SOAH DOCKET NO. 473-10-4790
PUC DOCKET NO. 38290

APPLICATION OF SHARYLAND § BEFORE THE STATE OFFICE
UTILITIES, L.P. TO AMEND ITS §
CERTIFICATE OF CONVENIENCE §
AND NECESSITY FOR THE §
PROPOSED HEREFORD TO WHITE § OF
DEER 345 KV CREZ TRANSMISSION §
LINE IN ARMSTRONG, CARSON, §
DEAF SMITH, OLDHAM, POTTER, §
AND RANDALL COUNTIES, TEXAS § ADMINISTRATIVE HEARINGS

**SHARYLAND UTILITIES, L.P.'S RESPONSES TO
CURRIE FAMILY INTERESTS' FIRST REQUEST FOR INFORMATION**

EXHIBIT CURRIE-SU 1-11

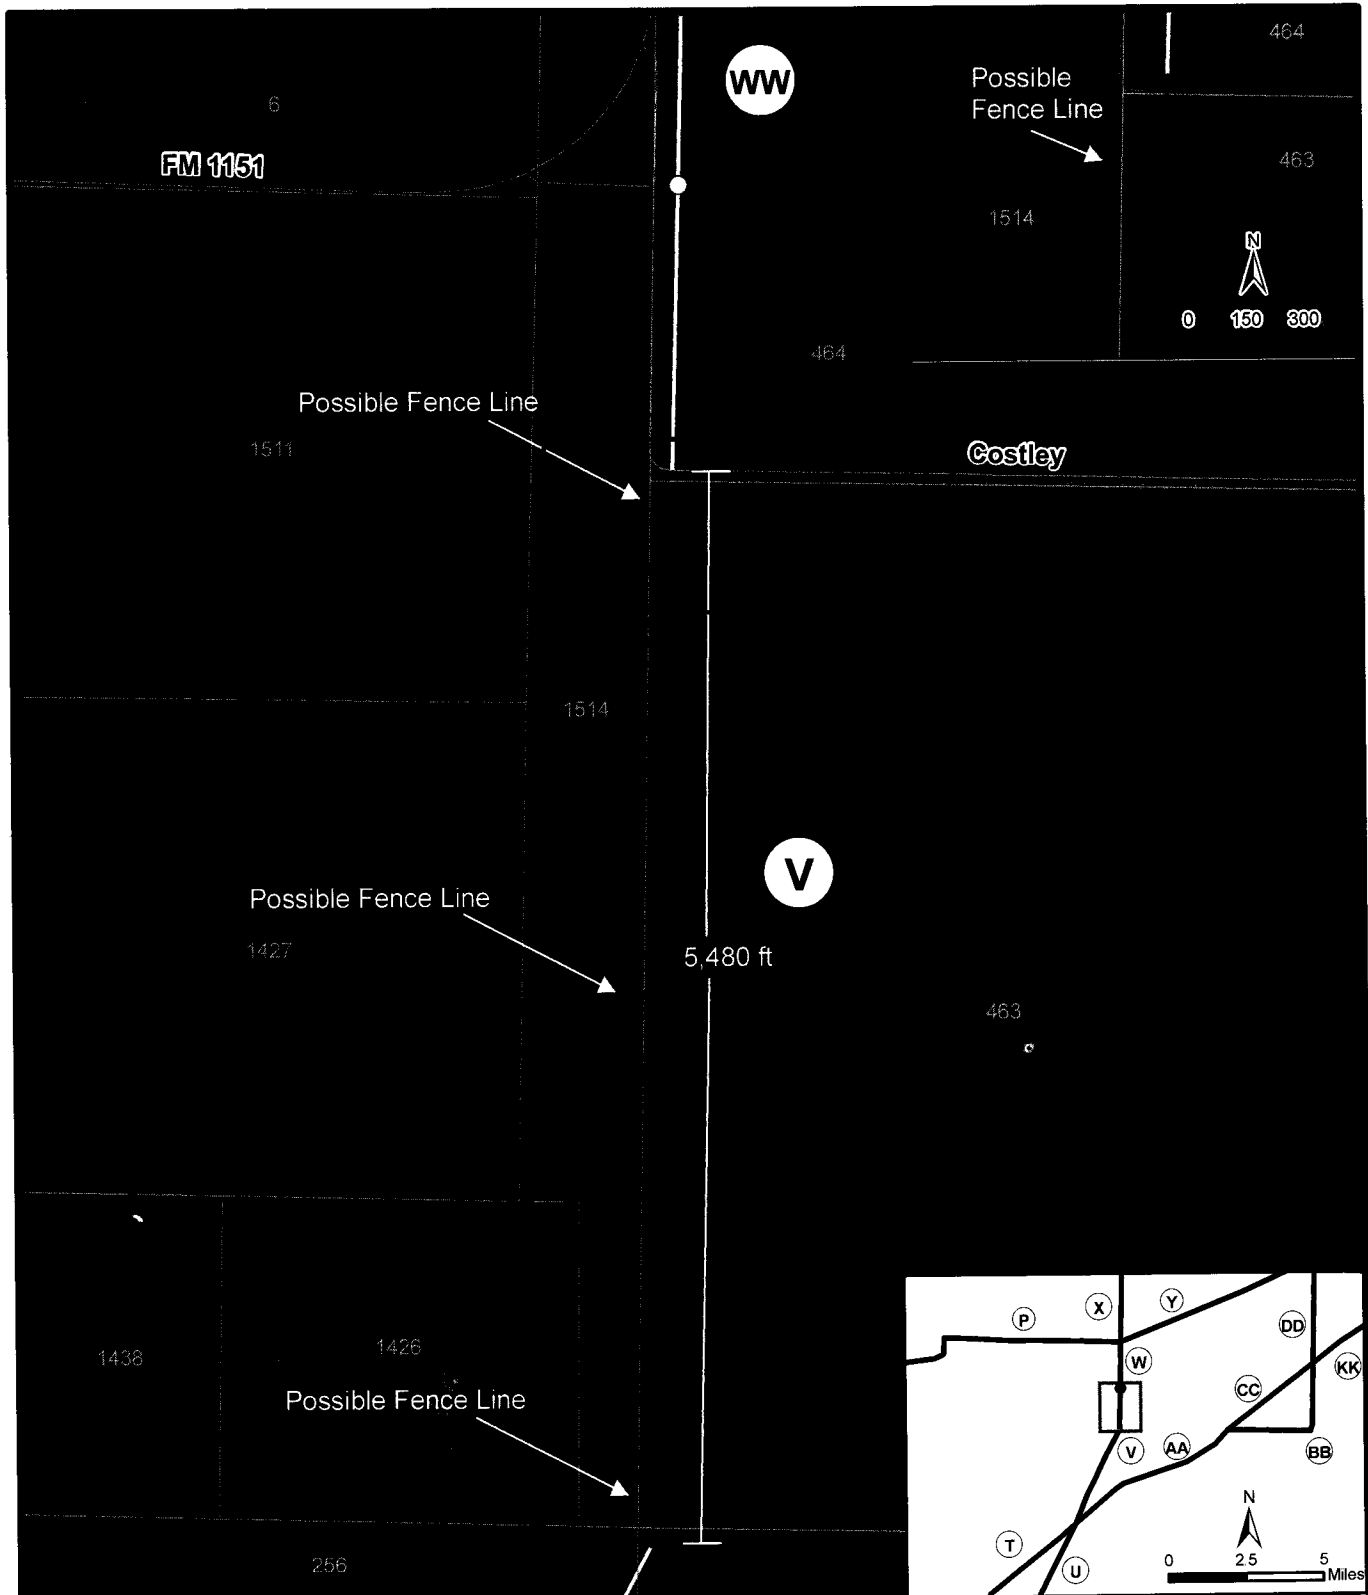
For each of Segments T, U, V, W, and AA, please state the length of each segment that parallels apparent property lines. Please indicate on a map where Sharyland contends that such segments parallel apparent property lines.

See Exhibit Seewald-SU 1-1 "Length of ROW paralleling apparent property lines (not following existing ROW)." See attached Exhibit CFI-SU 1-11. Length of ROW paralleling apparent property lines are measured along a route when no other existing transmission line right-of-way or other compatible right-of-way (roads, highways, pipelines, etc.) is paralleled. See also Section 4.6.1 of the Environmental Assessment.
